**CITY OF DES MOINES GENERAL SUPPLEMENTAL
SPECIFICATIONS TO THE
SUDAS STANDARD SPECIFICATIONS, 2021 EDITION
Effective Date: May 24, 2021**

This project will be constructed in accordance with the SUDAS Standard Specifications, 2021 Edition, which were adopted by the City of Des Moines on May 24, 2021, under Roll Call No. 21-????, as amended by these City of Des Moines General Supplemental Specifications.

Said SUDAS Standard Specifications are hereby amended as follows:

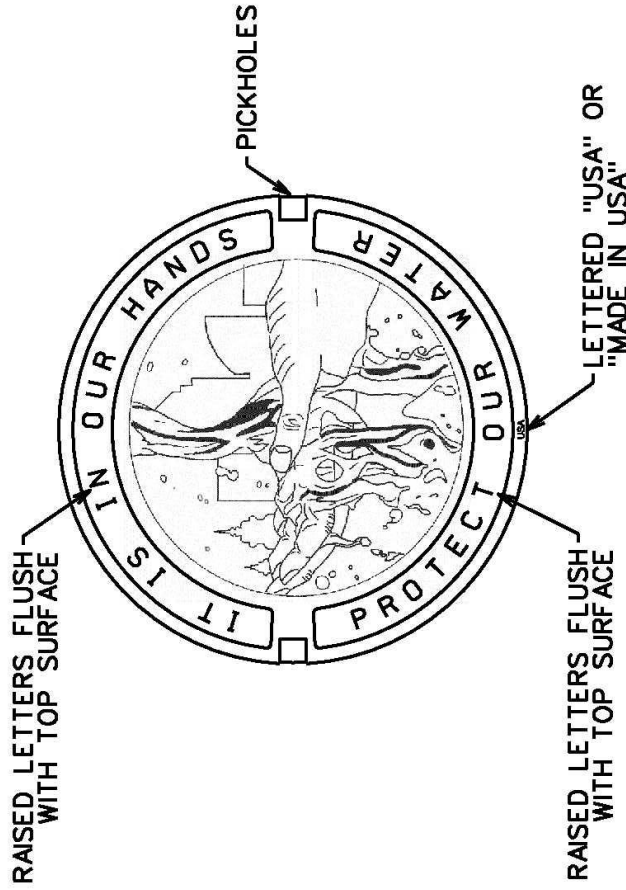
- b. Castings shall include design shown in this General Supplemental for lids on Type E, F, and G storm sewer castings shown for Figure 6101.602.

LID SHALL BE USED FOR TYPE E, TYPE F, AND TYPE G APPLICATIONS AS REFERENCED BY SUDAS FIGURE 6010.602.

MATERIAL: CAST GRAY IRON ASTM A-48, CLASS 35B
FINISH: NO PAINT
